# UNITED STATES PATENT AND TRADEMARK OFFICE

| APPLICATION NO.   | FILING DATE | FIRST NAMED INVENTOR | ATTORNEY DOCKET NO.       | CONFIRMATION NO.       |
|---|-------------|----------------------|---------------------------|------------------------|
| 10/578,983  | 08/08/2006  | Helge-Ruben Halse    | 007831.00004              | 8549                   |

## Office Action Summary

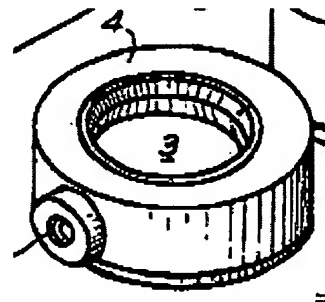
2. The disclosure is objected to because of the following informalities: In paragraph 39 (page 7, line 21 as indicated), the reference to back-up tong should be amended, i.e., "figures 1 and 2" should be changed to, --figure 5--.

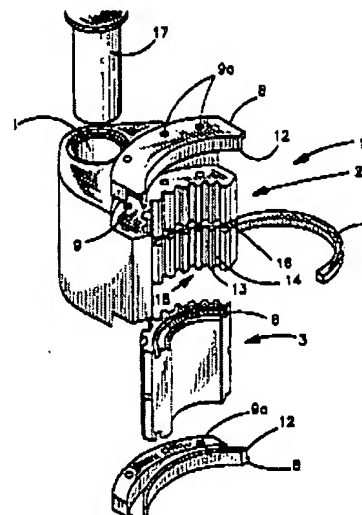
Montgomery et al. meets all of the limitations of claim 1, e.g., in Figs. 1-4, except for disclosing the clamping device communicating with the fluid supply via a swivel ring that encircles the drive ring, and that the plurality of the clamping devices (15) gathered in a group are removable from the drive ring. AAPA, e.g., page 1, lines 5-9, discloses that tongs having a swivel coupling surrounding the tong for transferring pressurized fluid from an external source to the tong is old and known in the art. It is further noted that it has been held that constructing a formerly integral structure in various elements involves only routine skill in the art. *Nerwin v. Erlichman*, 168 USPQ 177, 179. It would have been obvious to one having ordinary skill in the art at the time the invention was made to modify the invention of Montgomery et al with swivel coupling and to make the jaws separable for easing of maintenance or replacements, as these are old and well known in the art and would only require routine experimentations with predictable results.

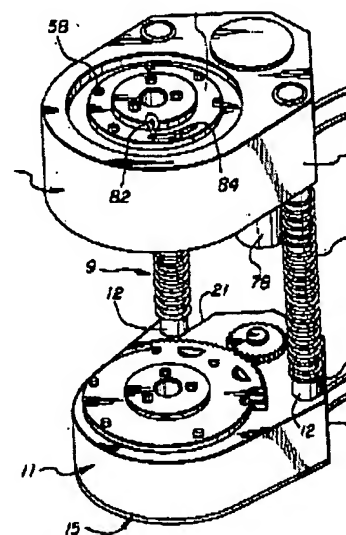
Prior art as applied to claim 1, meets all of the limitations of the above claims, except for disclosing a back up tong displaceable relative to the tong along two guide columns. Providing back up tong for break up and tightening of pipes and adjusting a relative distance between the tong and the back up tong along guide columns are known as evident by Keast et al. It would have been obvious to one of ordinary skill in the art, at the time the invention was made, to further modify the modified invention of prior art with guide columns as taught by Keast et al. to enhance the operation.

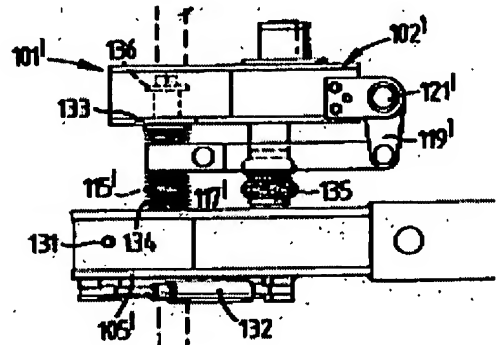
Prior art as applied to claim 1, meets all of the limitations of the above claims, except for disclosing a bellows between a back up tong and the tong. Providing back up tong for break up and tightening of pipes and providing a collecting bellows between the tongs is known as evident by Schulze-Beckinghausen. It would have been obvious to one of ordinary skill in the art, at the time the invention was made, to further modify the modified invention of prior art with a collecting bellows as taught by Schulze-Beckinghausen to enhance the operation.
